<b>Title: Pneumatic Clutch III &amp; IV – Plate Wear Limits</b>	
<b>AG-SIL-2021-02-EN</b>	<b>Effective Date:</b> 10 May 2021
<b>Applicability</b>	
<b>Aircraft type &amp; model:</b>  Calidus, Cavalon & MTO2017	<b>Affected Serial number(s):</b>  All models fitted with a pneumatic clutch incorporating a clutch plate without wear indication slots
The maintenance manual to be referenced is this stated or subsequent issue.	As per AutoGyro website
<p>This form is the response from AutoGyro GmbH either against a problem found in the product in service requiring a containment or rectification action, or as service information for aircraft modification incorporation. For help, contact AutoGyro on 49(0)5121 88056-00, or email <a href="mailto:airworthiness@auto-gyro.com">airworthiness@auto-gyro.com</a>.</p>

**Reason and overview of the Service Information Letter**

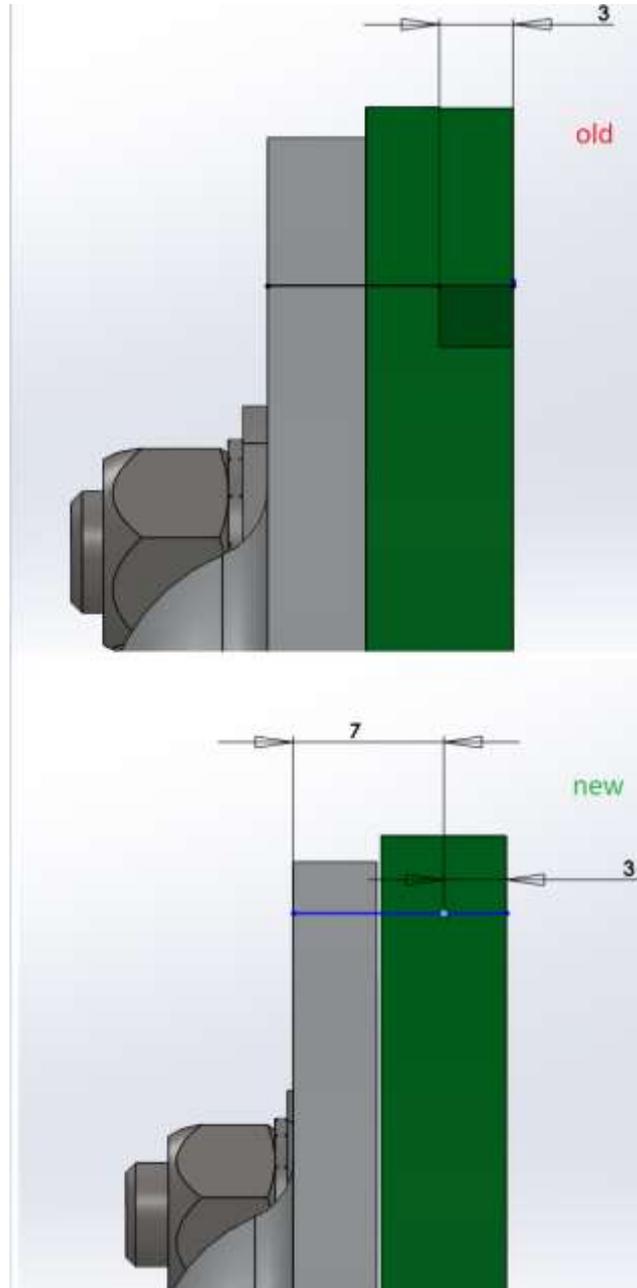
The new series of pneumatic clutch installed in AutoGyro Calidus, Cavalon and MTO2017 models, as well as the spare part replacement plate set (46137) are now produced and assembled without wear-limit grooves in the clutch pad.

The current inspection method for clutch plate wear stated in job card 63-11-10 6-1 of the respective maintenance manual is therefore no longer valid for clutches incorporating this type of plate. This SIL is the overriding authority in these cases.

This SIL provides instructions for the inspection of wear limits for clutch plates that do not have wear limit grooves.

The minimum thickness of pad and backing plate as per the diagram below is 7mm, regardless of the presence of wear limit grooves.
